## Arborist Addendum

To: Ken & Phoebe Chu  
Site: 4332 W Mercer Way, Mercer Island, WA, 98040  
Re: Tree Assessment  
Date: March 20, 2025  
Project Arborist: Connor McDermott-Grossman  
ISA Certified Arborist PN- 8704A  
ISA Qualified Tree Risk Assessor  
Referenced Documents: Site Plan A-010 (Shudan He, October 31, 2024)

This memo serves as an addendum to the arborist report provided by Tree Solutions Inc on May 9, 2024. I was asked to provide an updated assessment of the proposed site plans by Shudan He dated October 31, 2024, by the homeowner, Ken Chu.

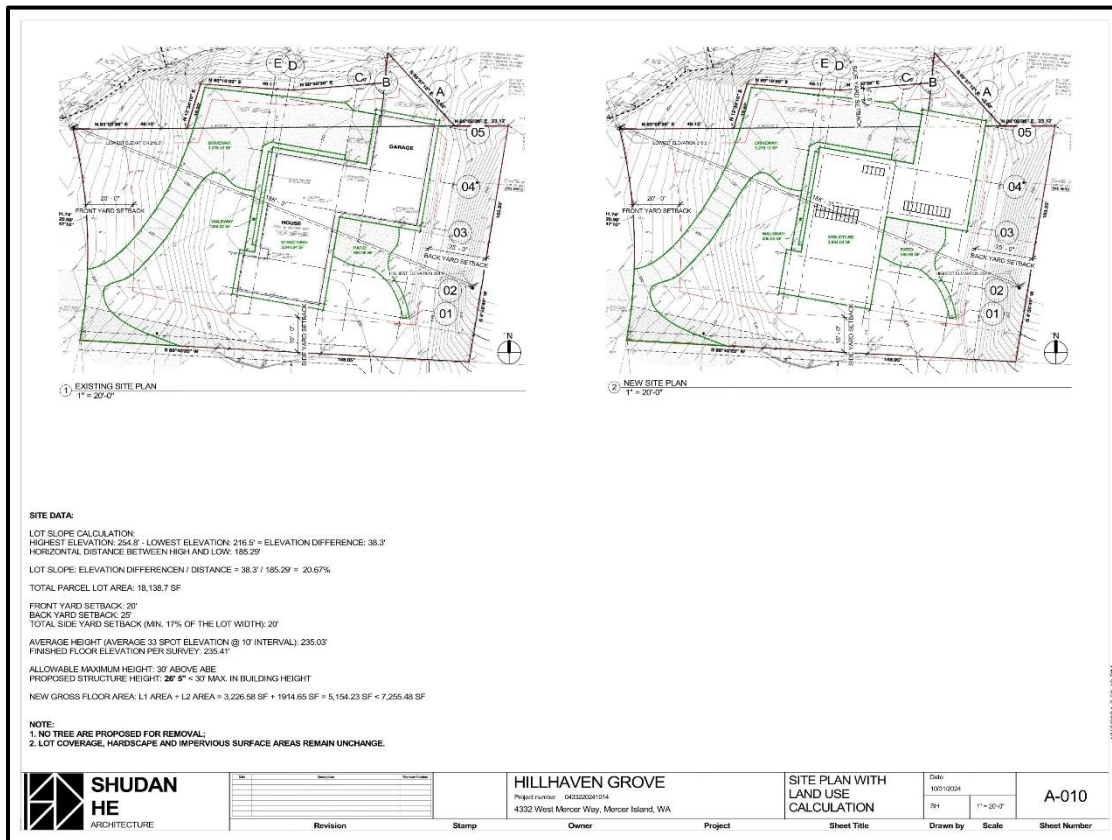
While no trees are proposed for removal the site plan does not detail tree protection on site. I recommend the site plan be updated to include the location of trees on-site and off-site, the recommended limits of disturbance (RLOD), and tree protection fencing. The RLODs for each tree can be found in the Tree Solutions Inc. report dated May 9, 2024. I recommend tree protection fencing to be installed at the hardscape limits on the north and west sides of the property (including trees 1, 18 through 40, E and D) and to the minimum limits of disturbance on the east side of the property (including trees 7, 10 through 15, 17, A, B, and C. Tree protection fencing should consist of 6-foot tall chain link fencing. Where trees are being retained as a group, I recommend the tree protection fencing extend to encompass the entire tree protection area.

No work should occur within the tree protection fencing. If any work is proposed within the tree protection areas the project arborist should be contacted and approved methods of excavation be utilized within these areas. If civil plans propose changes to the hardscapes or impervious surface areas, I recommend Tree Solutions Inc. reviews the plans in order to assess impacts to adjacent trees.
